Piper Aircraft Corporation

SUBJECT: Replacement or Modification of Muffler Shrouds

MODELS AFFECTED: PA-24 and PA-24 "250" Comanches - Serial Numbers 24-2588 to 24-2875 incl., 24-2877 to 24-2928 incl., 24-2930 to 24-2948 incl., 24-2950 to 24-2966 incl., 24-2968 to 24-2989 incl., 24-2991 to 24-3032 incl., 24-3034 to 24-3094 incl., 24-3096 to 24-3113 incl., 24-3115 to 24-3129 incl., 24-3131 to 24-3149 incl., 24-3151 to 24-3154 incl., 24-3156 to 24-3172 incl., 24-3174 to 24-3190 incl., 24-3192, 24-3195, 24-3197, 24-3199 to 24-3202 incl., 24-3205 to 24-3221 incl., 24-3223 to 24-3232 incl., 24-3235 to 24-3240 incl., 24-3242, 24-3243, 24-3245, 24-3246, 24-3247, 24-3249 to 24-3253 incl., 24-3255, 24-3256, 24-3259 to 24-3264 incl., 24-3266, 24-3267, 24-3269, 24-3271, 24-3272, 24-3275, 24-3281, 24-3284 and all of the referenced aircraft prior to Serial No. 24-2588 in which mufflers, part number 22594-00 and part number 22594-02 PA-24, and part number 22593-00 and part number 23159-00 PA-24 "250", have been installed as service replacements.

SERVICE BULLETIN NO. 210

A

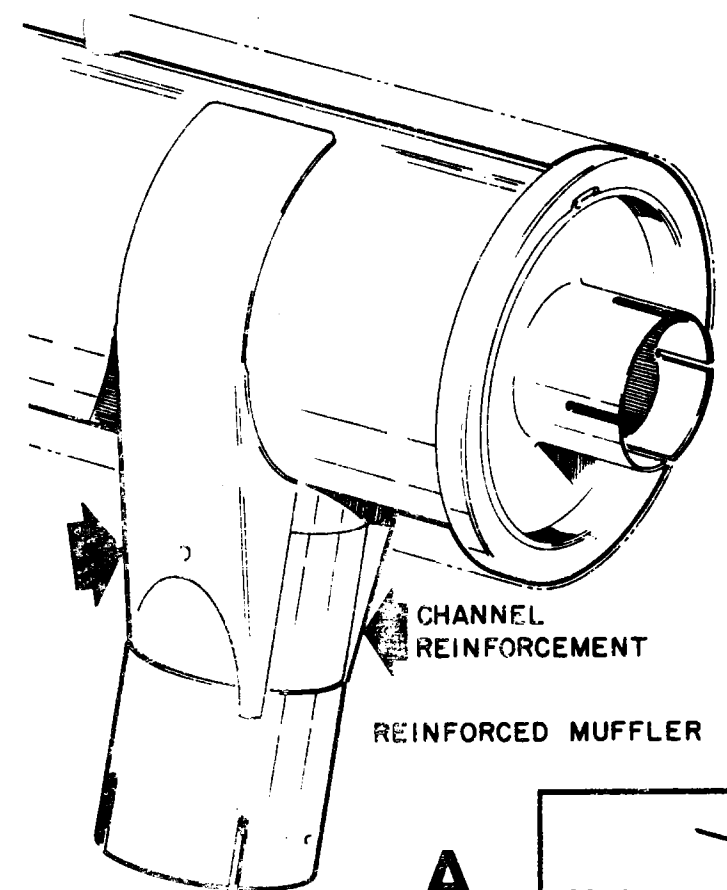
Comanche mufflers have been manufactured incorporating two different styles of tailpipe reinforcement brackets. However, this Service Bulletin requires modification of one style only; those with the channel-shaped reinforcement. See Sketch "A" for further identification. Both styles of muffler have been sold as service replacements. It will therefore be necessary to inspect aircraft, Serial Nos. 24-1 to 24-2587 inclusive if the original muffler has been replaced, to determine if compliance with this Bulletin is required.

CHANNEL
REINFORCEMENT
REINFORCED MUFFLER

B

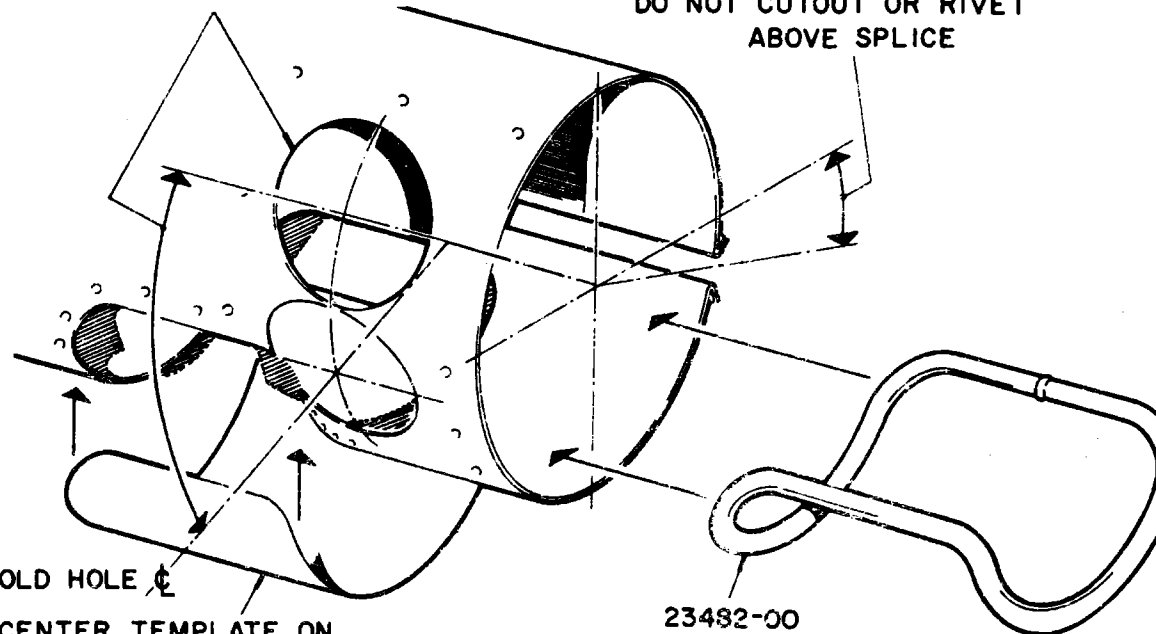
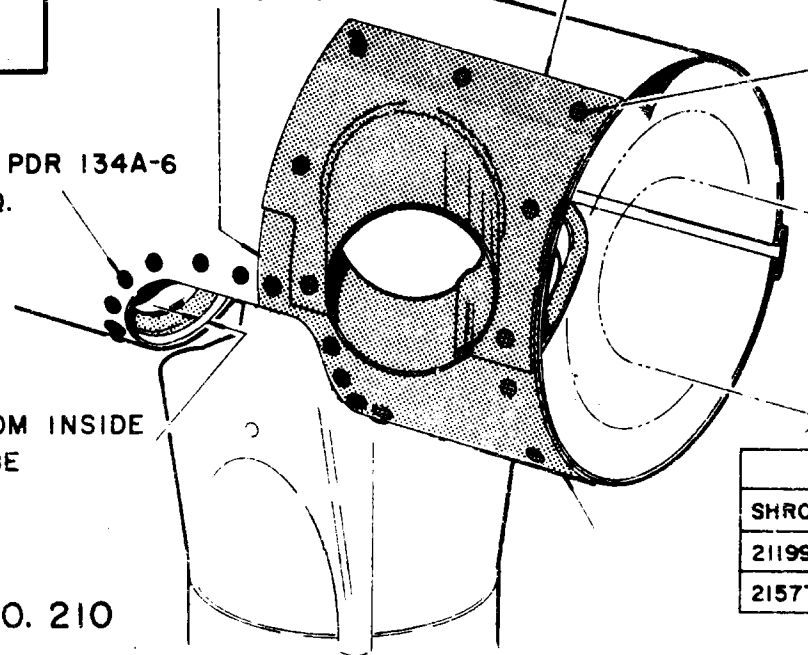
8. Cut the new opening in the aluminum shroud, taking care not to cut past the splice. (See Note Sketch "B.")
 9. Install the muffler housing reinforcement tube, part number 23482-00, on the inside of the aluminum heater shroud. (See Sketch "B.")

10. Relocate the cold air inlet take-off assembly as shown on the take-off relocation table and install cover plate, part number 23498-00, over old hole. Trim cover plate as required. (See Sketch "B.")

ON SHROUDS WITH SPLICE AT 45°
DO NOT CUTOUT OR RIVET
ABOVE SPLICE

OLD HOLE
CENTER TEMPLATE ON
OLD EXHAUST STACK HOLE
USING ATTACHED TEMPLATE

CUTOUT APPROX. $\frac{1}{8}$ " FROM INSIDE
OF REINF. TUBE

23482-00

COVER PLATE 23498-00

RIVET PDR 134A-6
20 REQ.

RIVET AN426A3-4
11 REQ.
